REVISION: OVERSIGHT CONCERN - DATED FEBRUARY 23RD, 2022
SHEETS: A102, A103, A105, A200, A201, A203, A204, A300, A4.03

NO.	DESCRIPTION	DATE
1	REVISED AS PER CITY COMMENTS - DP	2021-10-27
2	OVERSIGHT COMMENTS	2022-02-23

364 E 14TH STREET
DUPLEX INFILL
COVER SHEET

DUPLEX INFILL
INFILL - S & W ELEVATIONS (LDC)

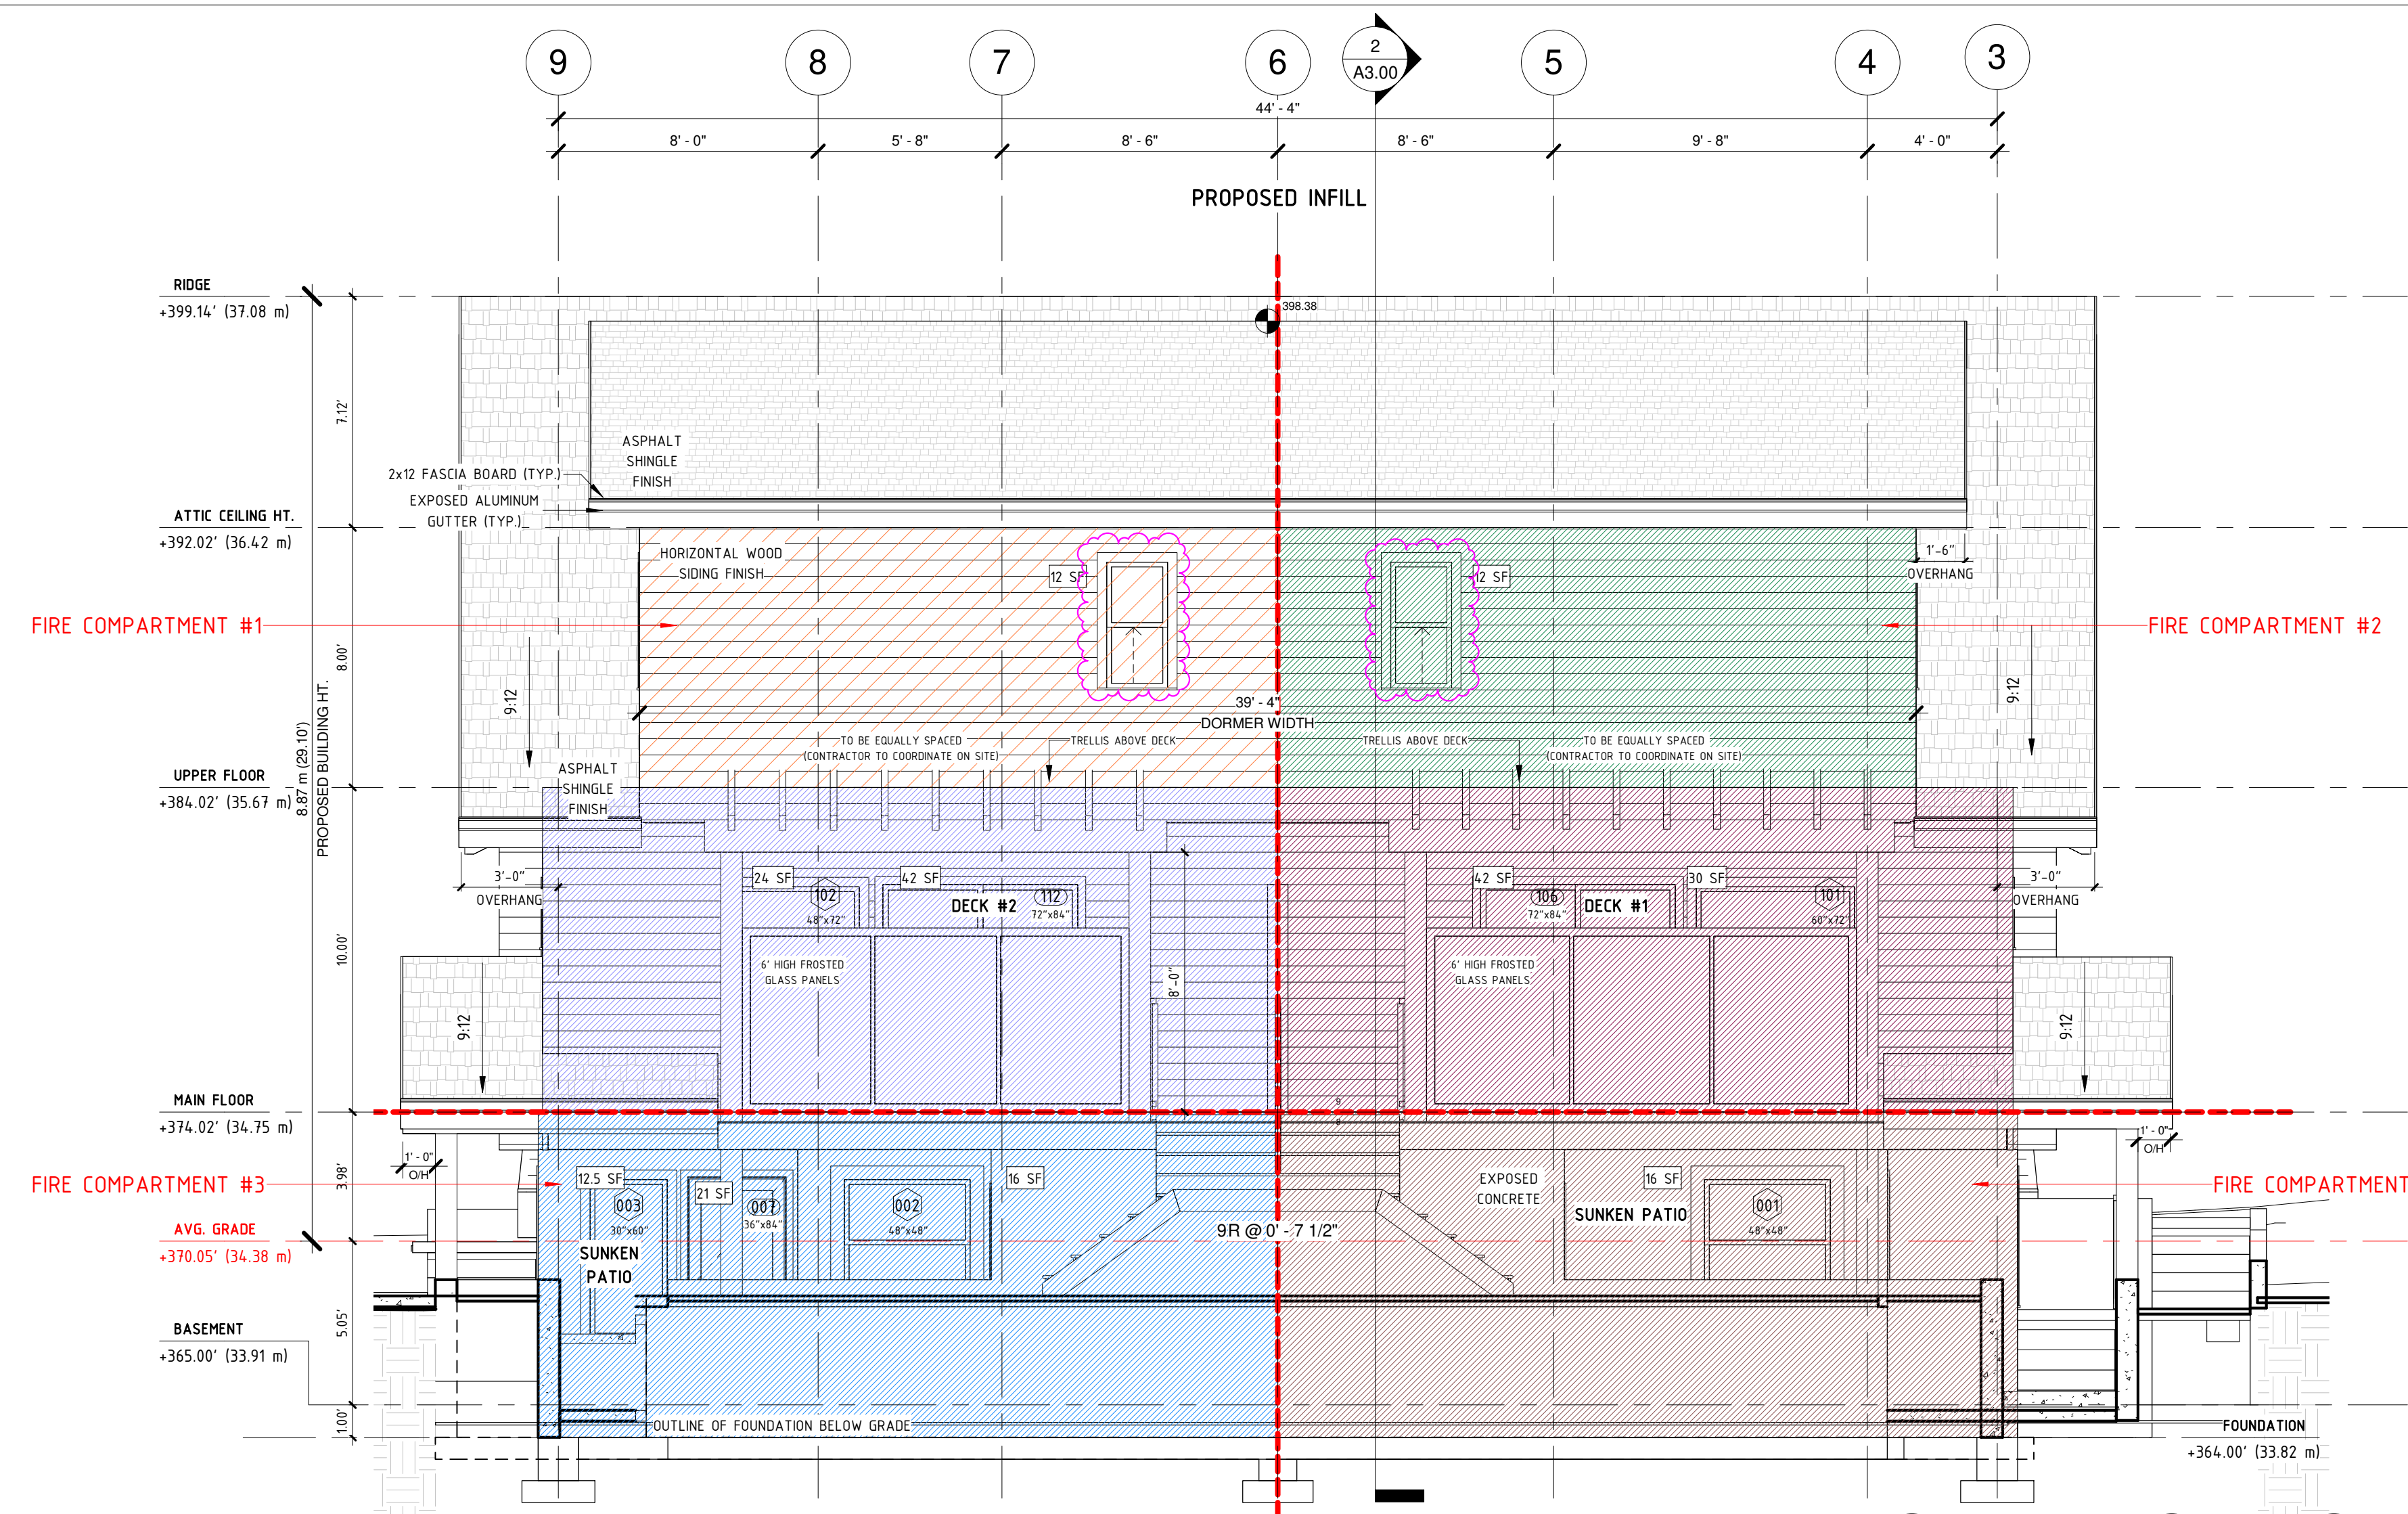
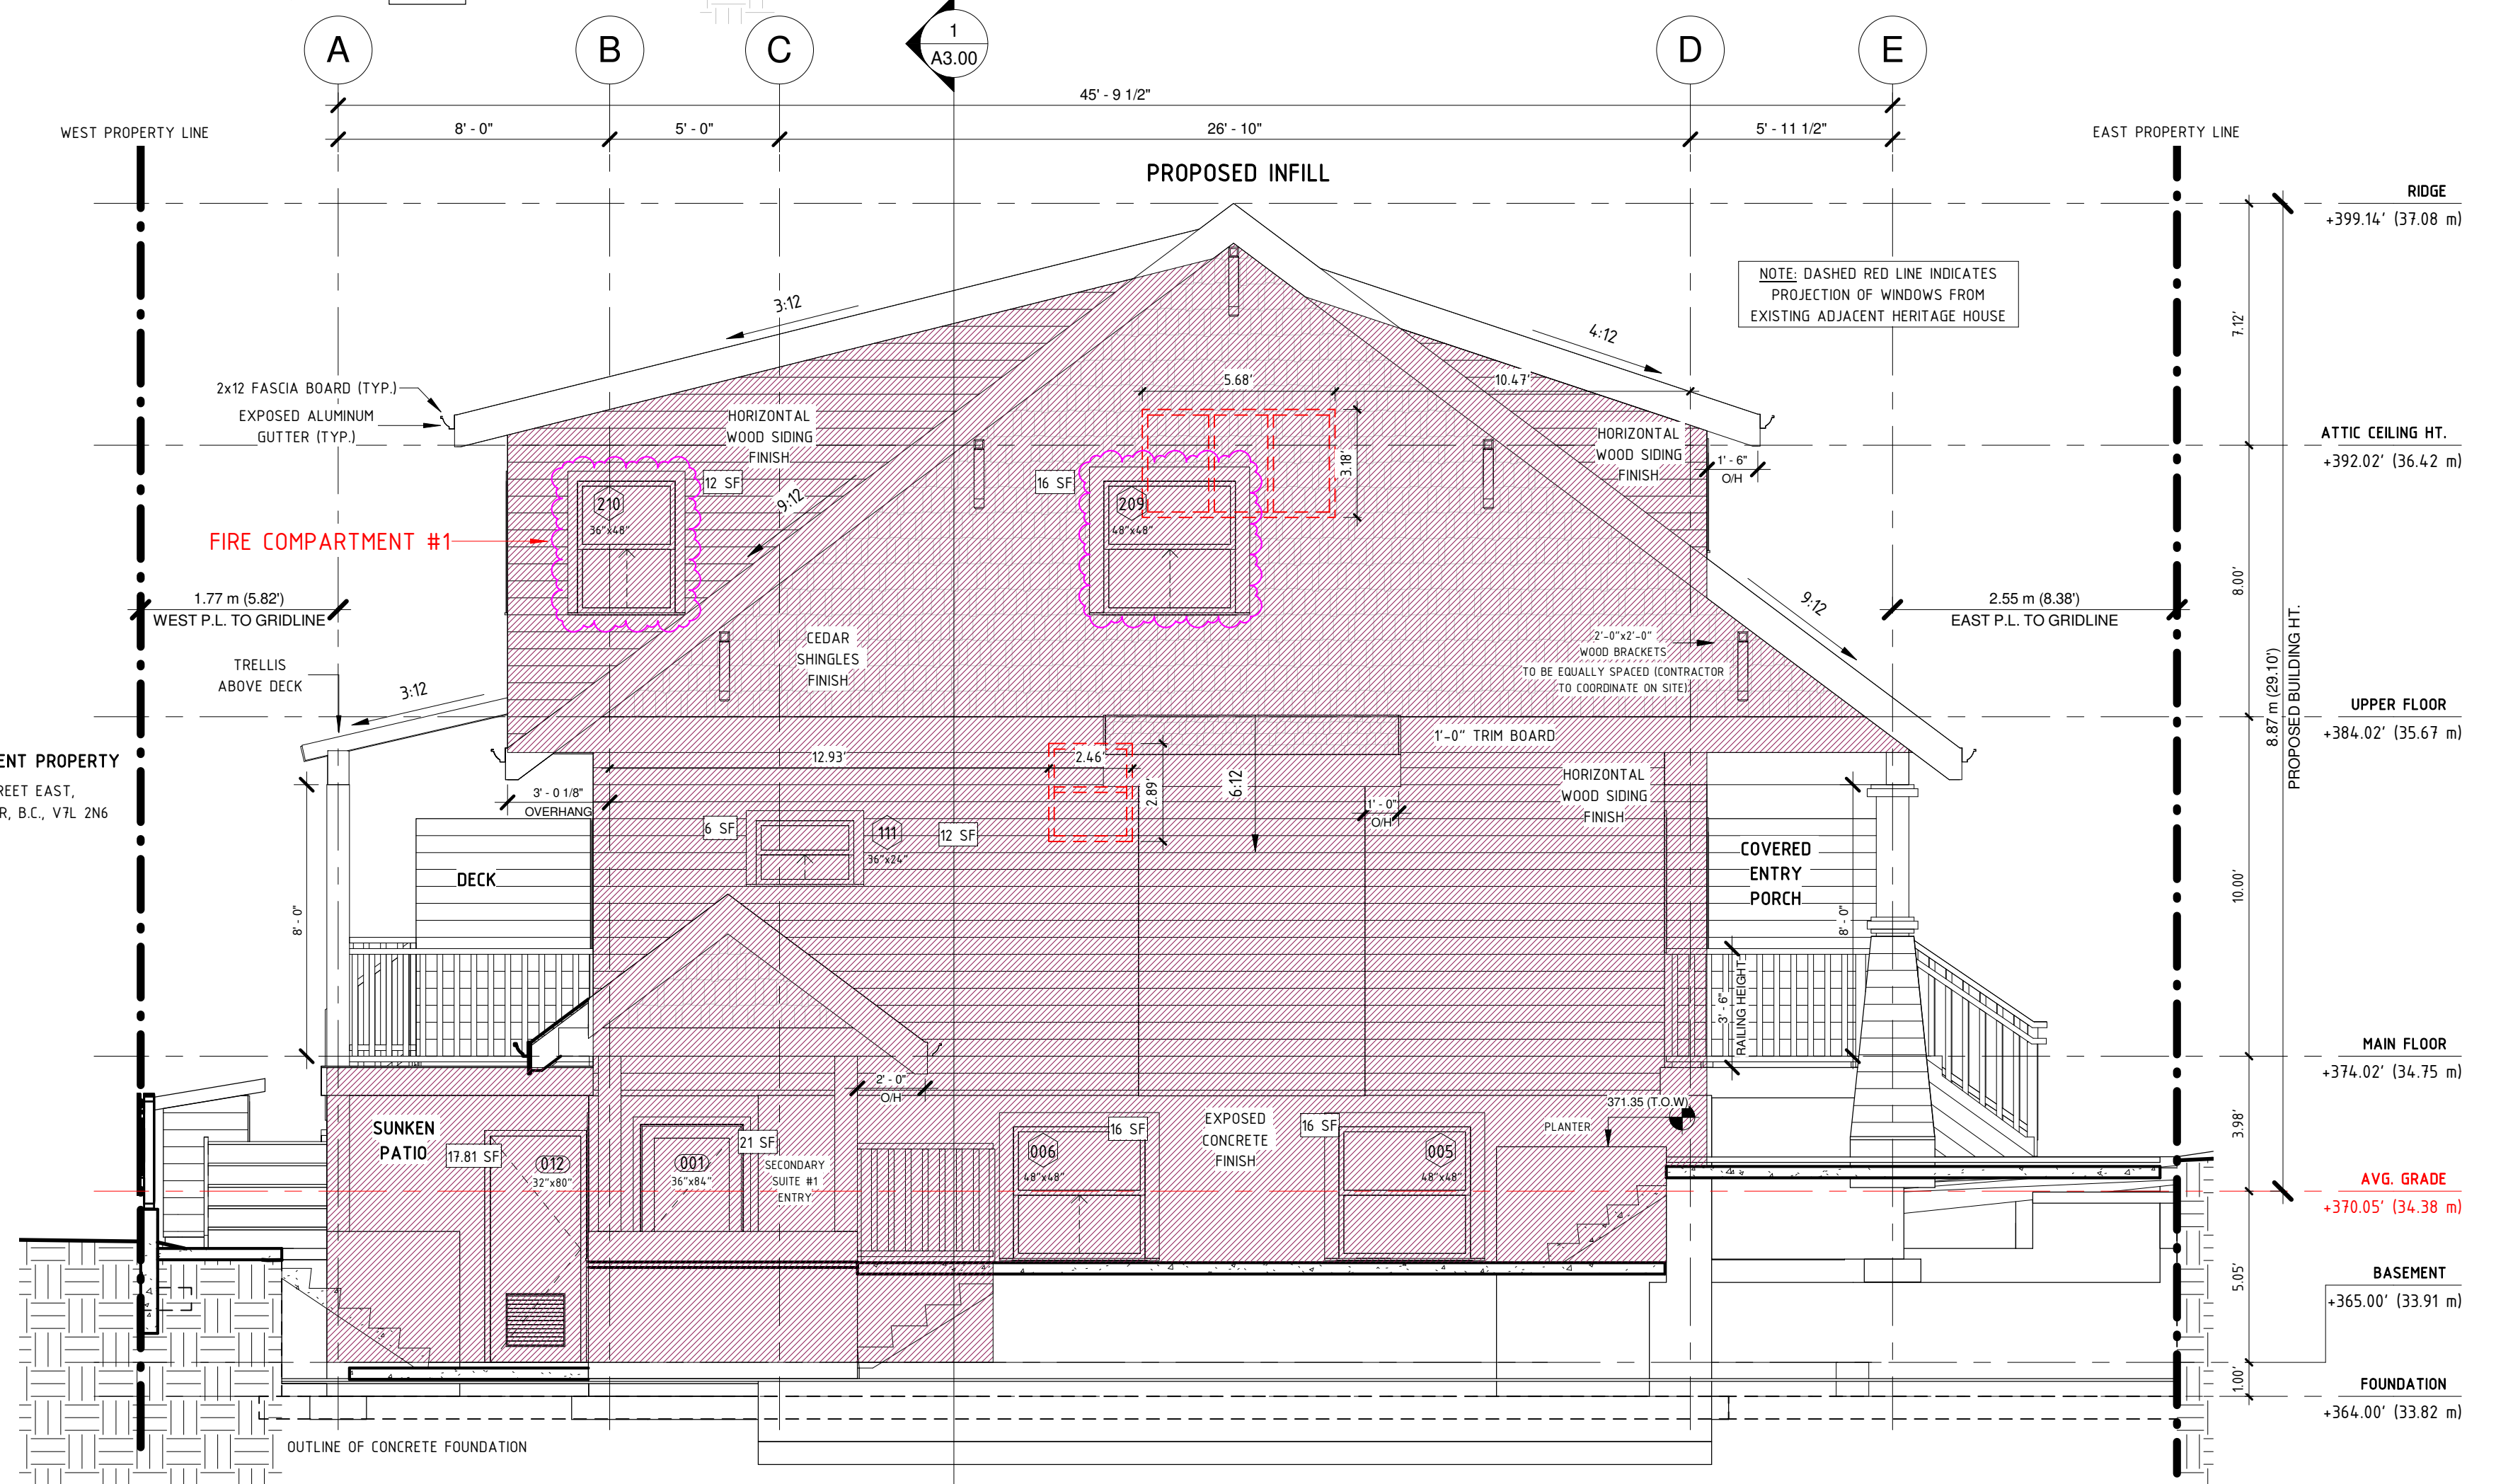
REVISIONS
SPATIAL SEPARATIONS CALCULATIONS UPDATED AS PER LAYOUT CHANGES
